ADDENDUM A

Nebraska Educational Telecommunications (NET)
Lower Level – Office Remodel
1800 N. 33rd Street
Lincoln, Nebraska
RDG Project No. 2012.196.00, File 35.1

RDG Planning & Design
900 Farnam on the Mall, Suite 100
Omaha, NE 68102-5089
(402) 392-0133

2 FLOOR PLAN
1/8" = 1'-0"

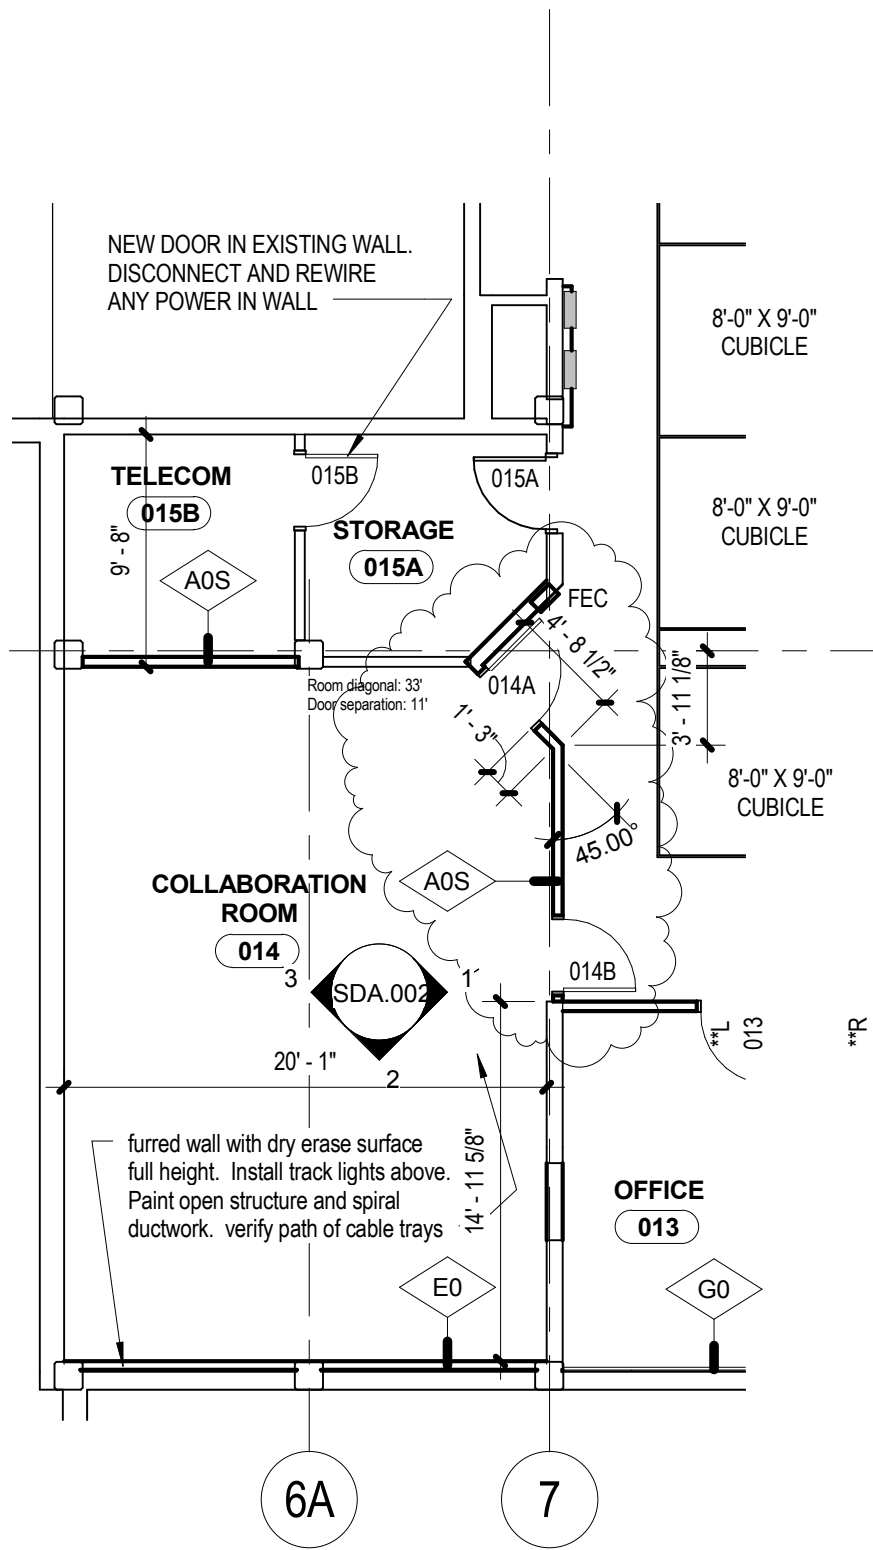
A. Floor Plan, Room 014: See Supplemental Drawing SDA.001 for revised floor plan. Change sliding door to a swinging door into Room 014, and add a second door to the room per the attached sketch.

3 REFL CEILING PLAN
1/8" = 1'-0"

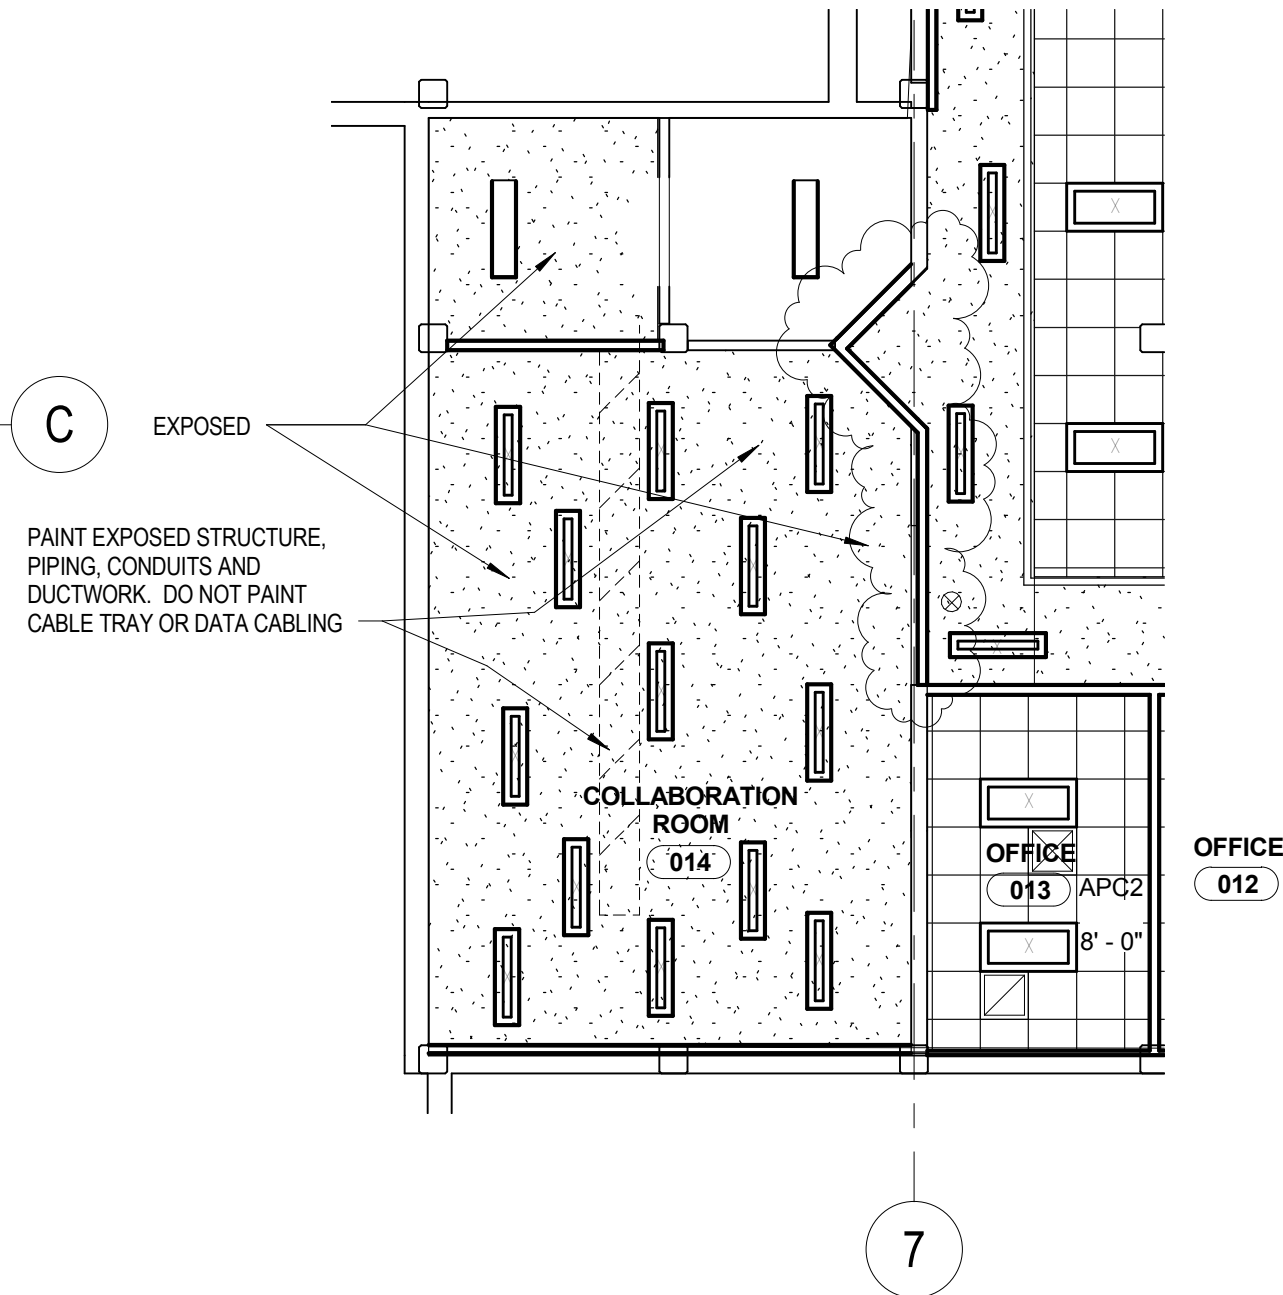
- A. Reflected Ceiling Plan: See attached Supplemental Drawing SDA.001 for revisions at Room 014.
- B. Elevation 1/A13.01: See attached Supplemental SDA.002 for revised interior elevation.
- C. Delete Detail 9/A13.01; detail is no longer used.
- D. Interior Elevations 1, 2, 3, 4, and 6: Change ceiling paint color to **"P5."**

1 DEMO FLOOR PLAN
1/8" = 1'-0"

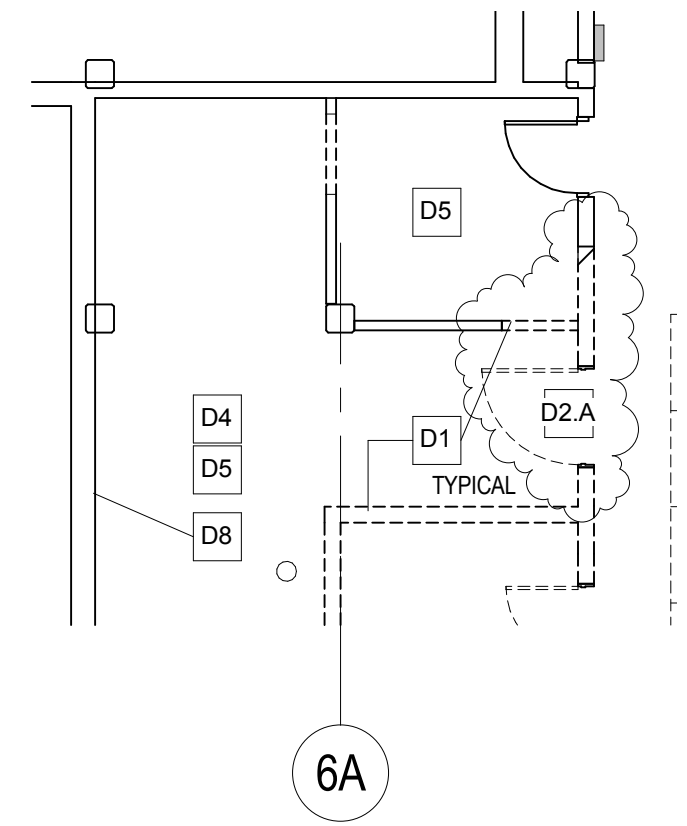
B. Demolition Plan: See attached Supplemental Drawing SDA.001.

DOOR TYPE F3 - REVISED
1/4" = 1'-0"

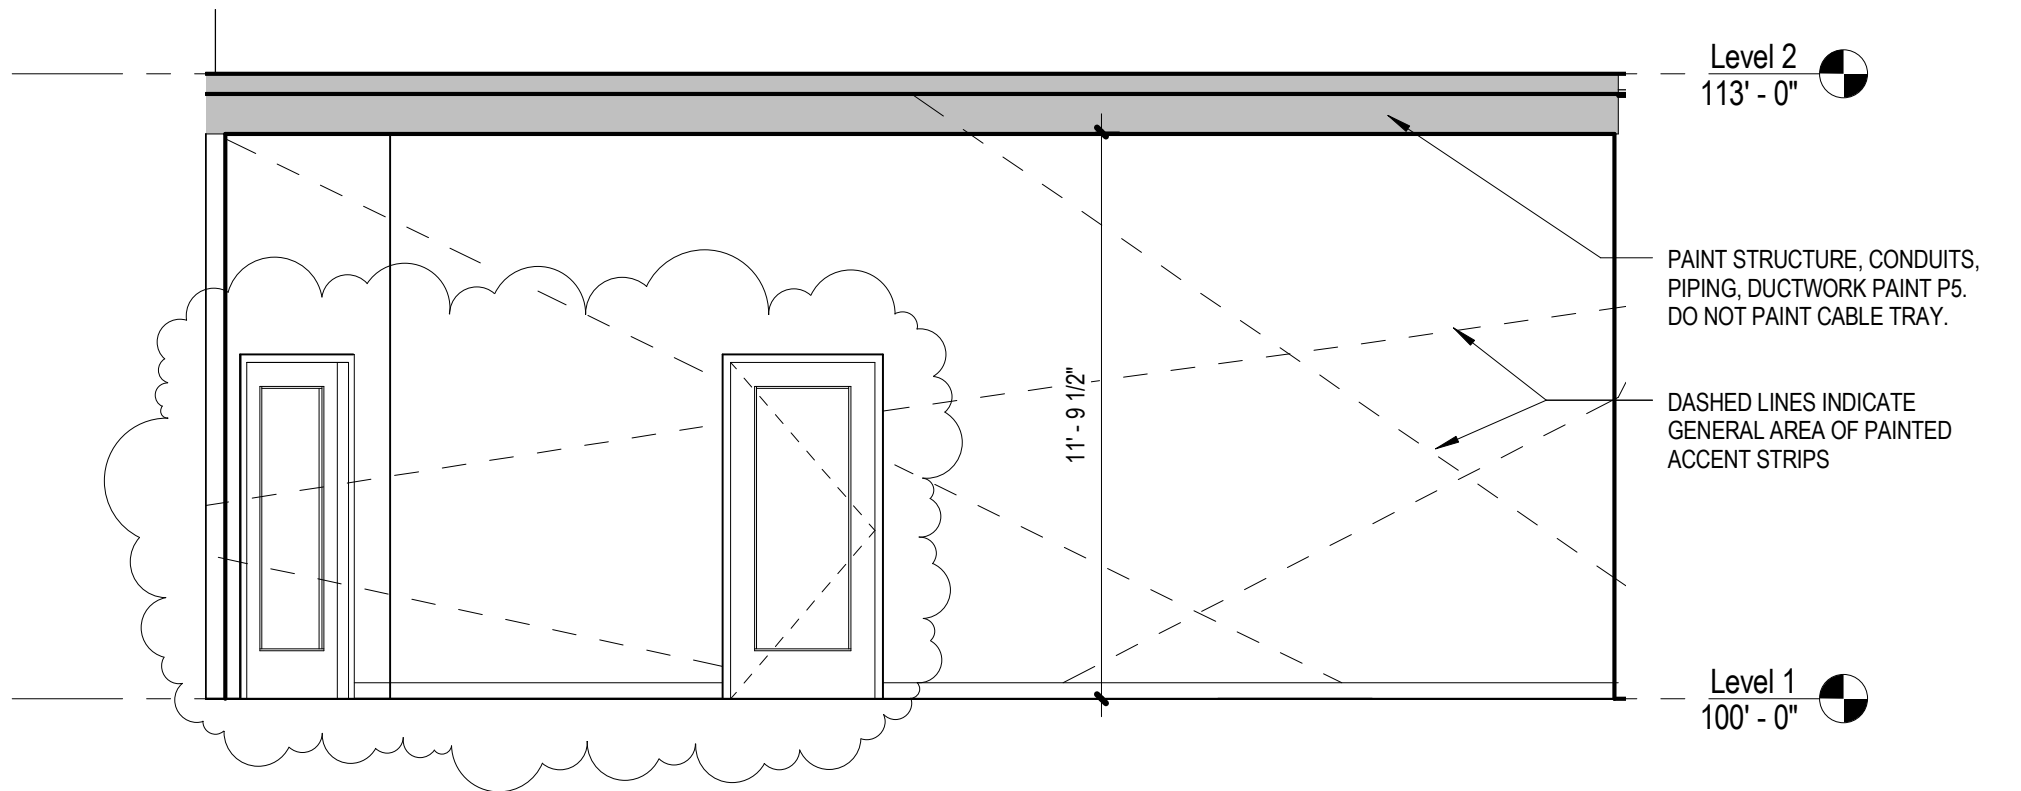
- C. Door Schedule: See Supplemental Drawing SDA.002 for revised Door Schedule.
- D. Door & Frame Types: Delete Frame Types F3 and F3-Alt. See attached Supplemental Drawing SDA.002 for revised Door/Frame Type F3. F3-Alt is no longer used.
- E. Door Schedule Notes: Add Note 3 as follows:
 - 3. FOR SALVAGED DOORS AND FRAMES, MARK DOORS AND FRAMES AND HARDWARE TO BE REUSED AND KEEP DOORS AND FRAMED TOGETHER.**
- F. Door Schedule Notes: Add Note 4 as follows:
 - 4. INSTALL OWNER PROVIDED SIGN AT EACH OFFICE DOOR.**

PROJECT NO. 20123238	DATE 04-19-2013	DRAWING REFERENCED: ADDENDUM NO.:	M00.02 1	SKETCH MS-1
-------------------------	--------------------	--------------------------------------	-------------	----------------

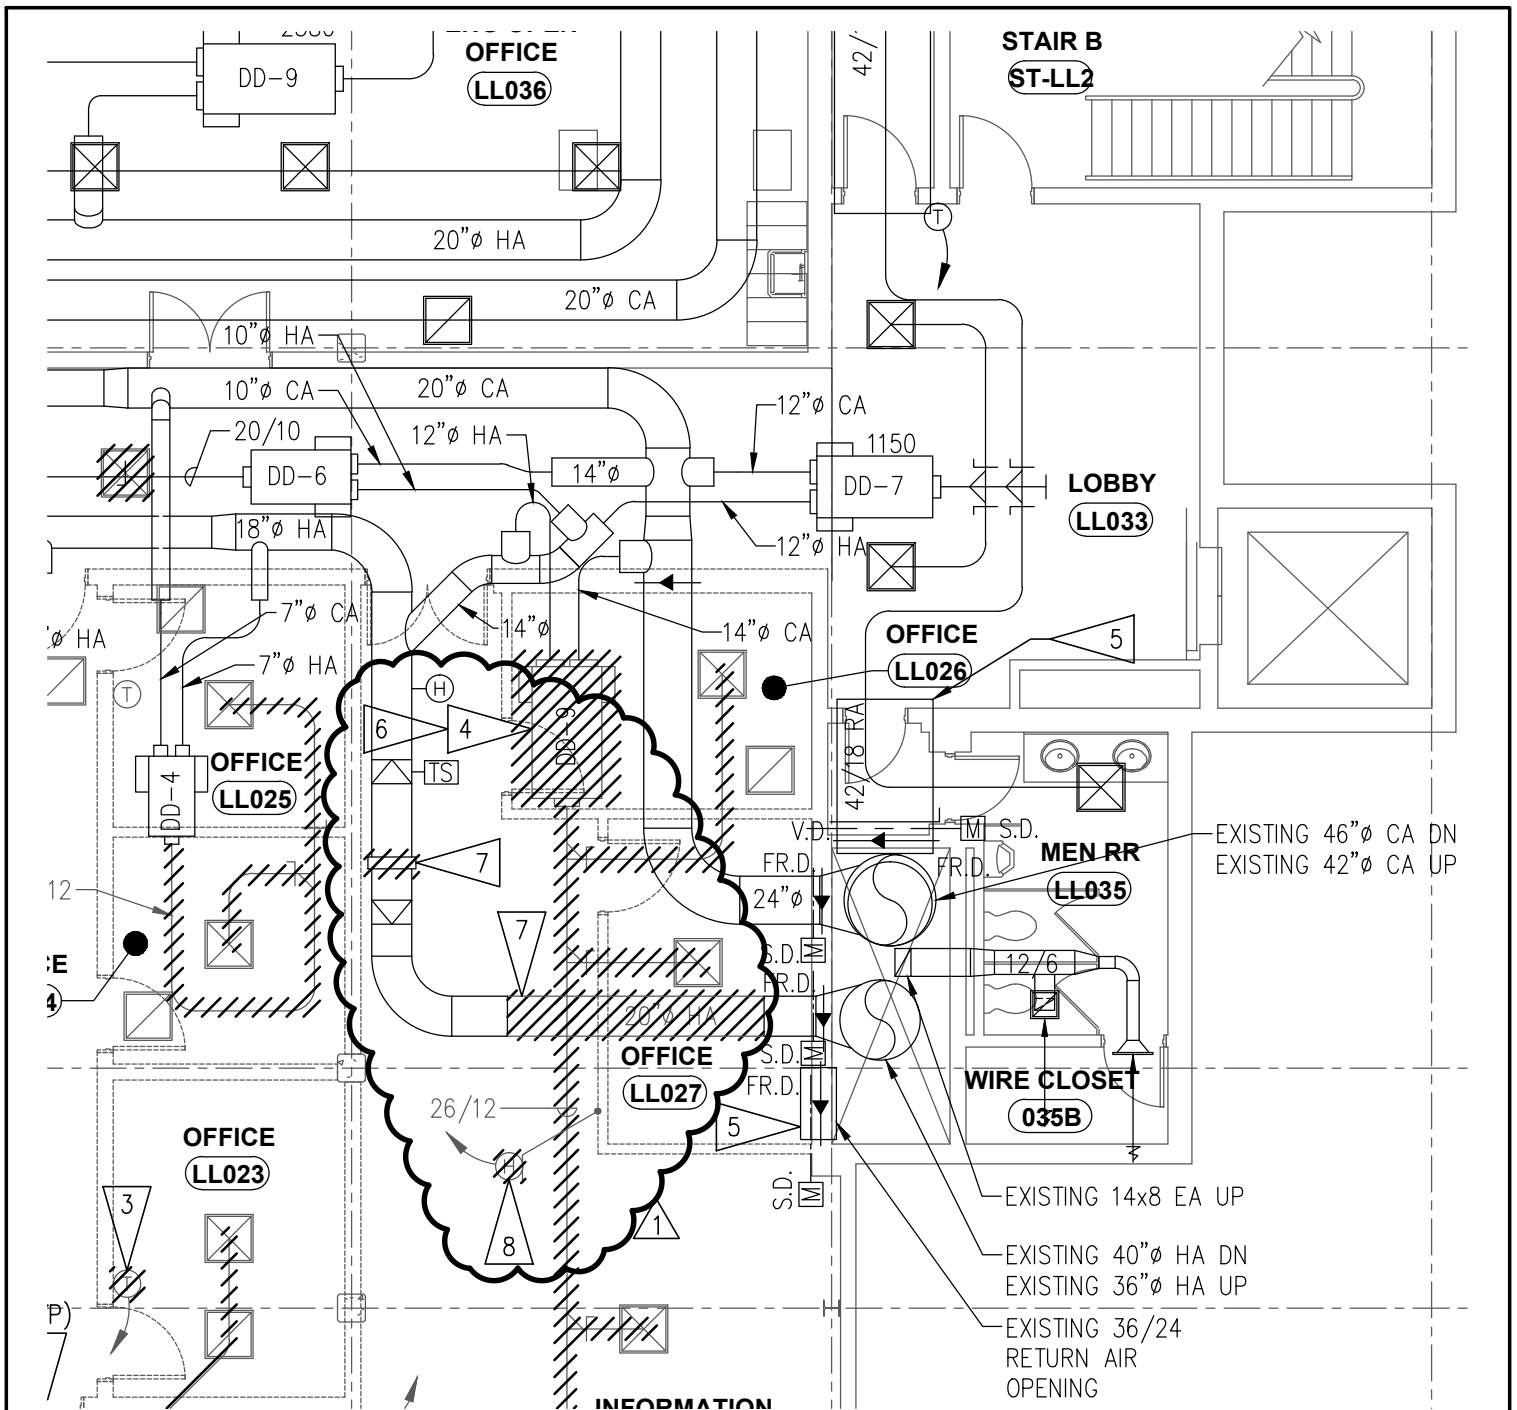
- A. Remove the existing ductwork, as required, for relocation of the existing humidifier as clouded on Mechanical Sketch Sheet MS-1.
- B. Add the following to the end of Flag Note No. 5:
 - 5. ... INCLUDE ALL PROVISIONS FOR TEMPORARY POWER TO THE FAN AS REQUIRED.**

SEE SHEET M00.01 FOR DEMOLITION WORK IN THIS AREA PER BID ALTERNATE NO. 3.

PER BID ALTERNATE NO.3, REMOVE EXISTING WALL MOUNTED HUMIDISTAT FOR THE EXISTING HUMIDIFIER AND RETURN TO OWNER.

DRAWING REFERENCED: M01.01
ADDENDUM NO.: 1

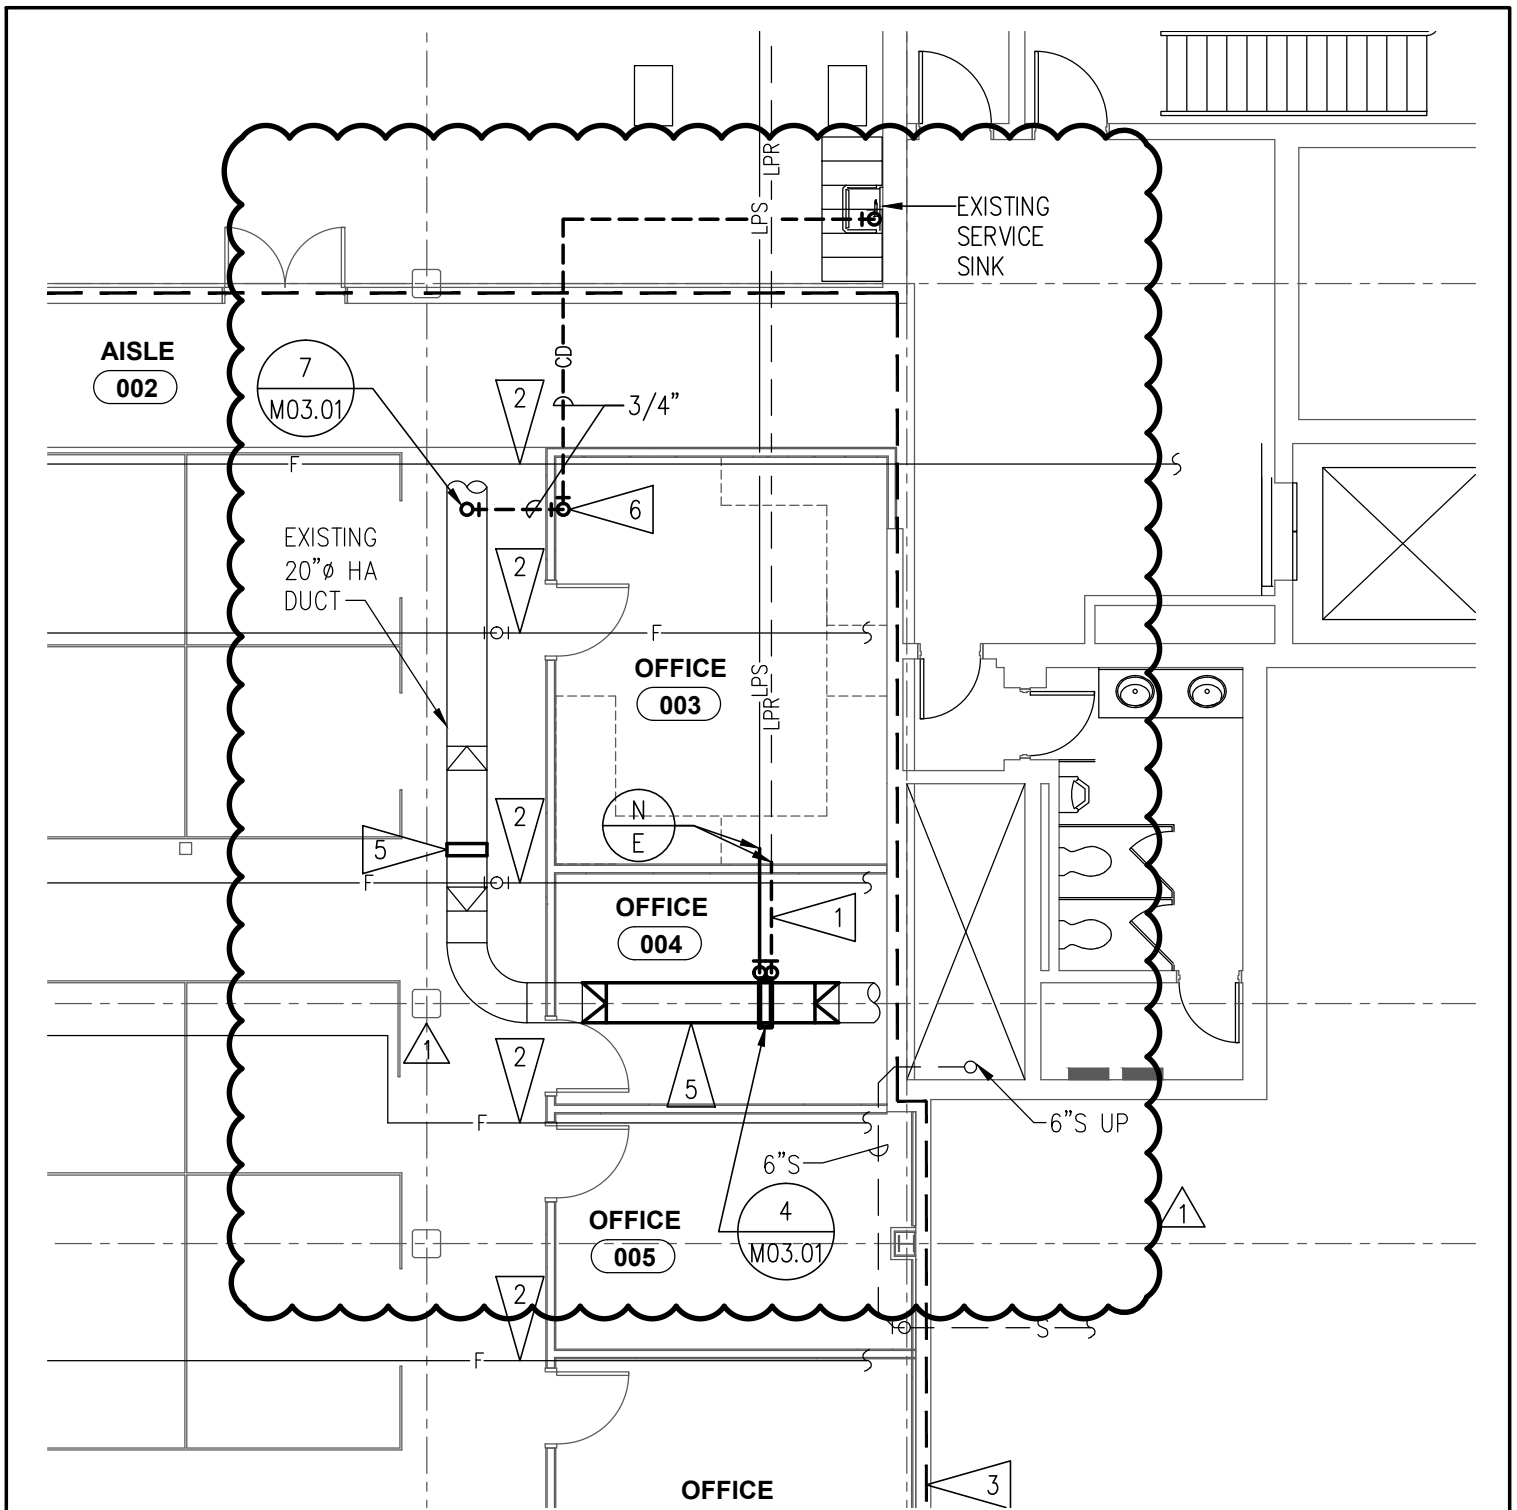
- A. Install the humidifier and piping as clouded on Mechanical Sketch Sheet MS-2.
- B. Add the following Note 9 to the Plumbing General Notes:
 - 9. ALL CD PIPING SHALL BE TYPE M COPPER WITH WROUGHT COPPER FITTINGS AND SOLDERED JOINTS. ALL CD PIPING SHALL BE INSULATED PER SPECIFICATION SECTION 230719.**

PER BID ALTERNATE NO.3, DUCTWORK TO BE PATCHED/MODIFIED PER SHEET M02.01.

PER BID ALTERNATE NO.3, INSTALL HA DUCT HUMIDIFIER CD TRAP AS A PREVENTATIVE MEASURE ABOVE OFFICE 003 AND SLOPE PIPING TO INDIRECTLY DRAIN TO THE EXISTING SERVICE SINK.
